Access Compliance Report Public Rights-of-Way (Curb Ramps)

Main Street: RED_HILL_AVE Cross Street: GARLAND_AVE Location: E

ADA ID: RPRK211014143523 Ramp Type: Type 4 - Parallel Initial Pass/Fail: Fail Overall Compliance: No Severity Score: 16

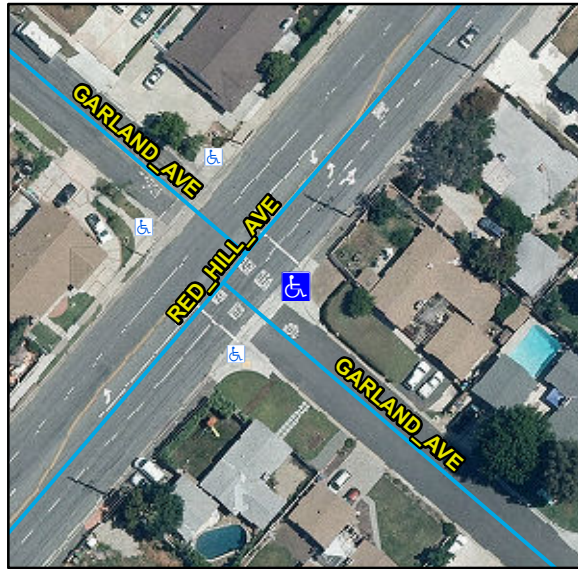
Compliance	Description	Data	Compliance	Description	Data
N/A	Ramp Length LT (in)	77	N/A	Ramp Length RT (in)	72
Yes	Ramp Width LT (in)	55	Yes	Ramp Width RT (in)	51
Yes	Ramp Run Slope LT (%)	7.3	No	Ramp Run Slope RT (%)	8.6
Yes	Ramp Cross Slope LT (%)	0.1	No	Ramp Cross Slope RT (%)	2.2
N/A	Landing Present	N/A	N/A	DWS Provided	N/A
N/A	Landing Length (in)	N/A	N/A	DWS Contrast	N/A
N/A	Landing Width (in)	N/A	N/A	DWS Length (in)	N/A
N/A	Landing Run Slope (%)	N/A	N/A	DWS Full Width	N/A
N/A	Landing Cross Slope (%)	N/A		DWS Offset Type	N/A
N/A	Landing Movement Obstructed?	N/A	N/A	DWS Offset Left (in)	N/A
	Landing Movement Type	N/A	N/A	DWS Offset Right (in)	N/A
N/A	Landing Shared	N/A			
N/A	Clear Space	Yes			
N/A	Clear Space To Crosswalk (in)	N/A			
N/A	Marked Crosswalk 1	No	N/A	Marked Crosswalk 2	No
	Crossing 1 Direction	NW		Crossing 2 Direction	SW
	Marked Crosswalk 1 Width (in)	N/A		Marked Crosswalk 2 Width (in)	N/A

Remove & Replace Curb Ramp With Two New Directional Ramps or Equivalent.
